Exeter Airport Airspace Change Proposal

Options Development

Reference	Description
Document Title	Exeter Airport Airspace Change Proposal
	Options Development
Document Ref	71189 031
Issue	Issue 5
Date	28 th February 2025
Client Name	Exeter & Devon Airport Ltd

A4.3 Option 3

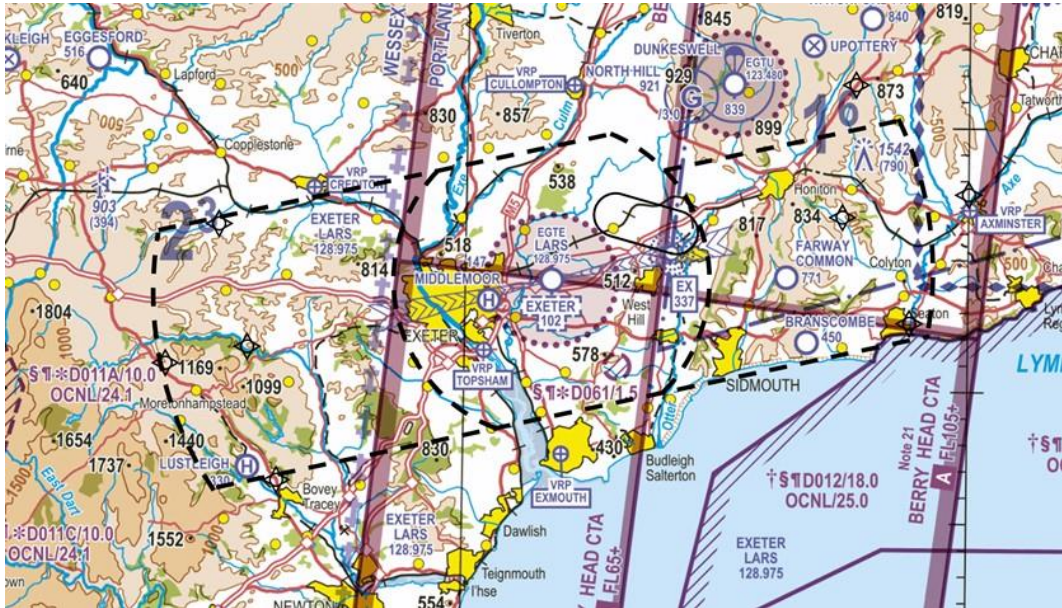
Exeter Airport notes the comment that Option 3 as presented might be a viable option. Despite considering this option to be unviable, Exeter Airport will include this option, with extended stubs, going forward.
